Technical Service Bulletin

94 Xenon headlights are adjusted too low

94 15 62 2032852/3 February 19, 2015. Supersedes Technical Service Bulletin Group 94 number 13-09 dated February 26, 2013 for reasons listed below.

Model(s)	Year	VIN Range	Vehicle-Specific Equipment
A4	2013 - 2016	All	Not Applicable

Figure 1. Model year 2009 - 2012 A4 xenon headlight beam pattern.

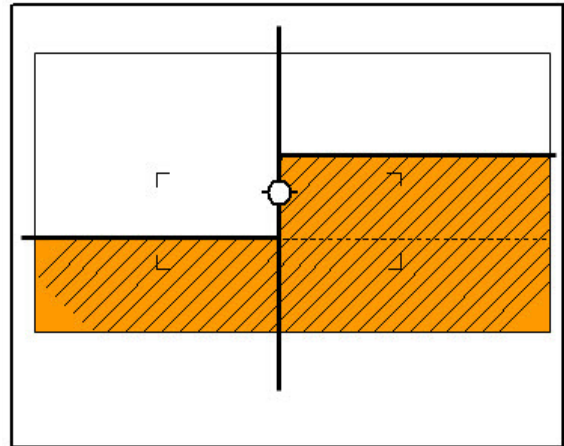
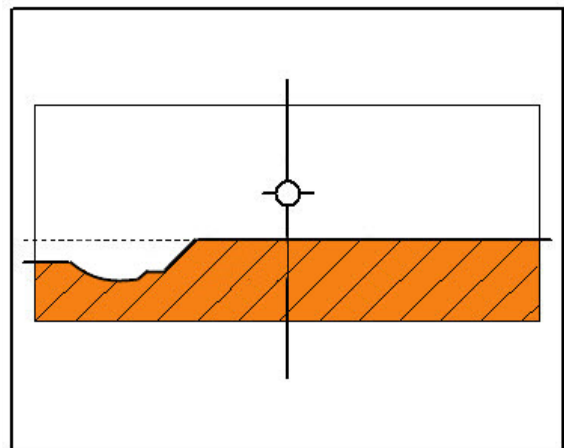
Distinct cut-off beam pattern: The light distribution of the headlights on model year 2009 - 2012 A4 vehicles has a very sharp cut-off beam pattern (Figure 1). This is most noticeable when the vehicle is driven through long dips in the road (such as when coming to the bottom of a large hill).

Modified light distribution for A4 product improvement vehicles (starting in model year 2013): The illumination of the headlight has been changed for these vehicles to help further reduce the amount of light seen by oncoming traffic (Figure 2).

Figure 3. Comparison of new and previous generation headlight beam pattern

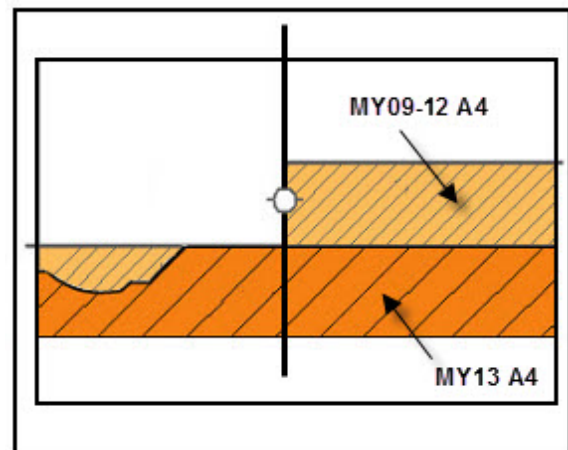
Explain to the customer the changes in the beam for A4 product improvement vehicles (Figure 3). Explain the risks of adjusting the beam too high, which may cause an unsafe condition for oncoming traffic.
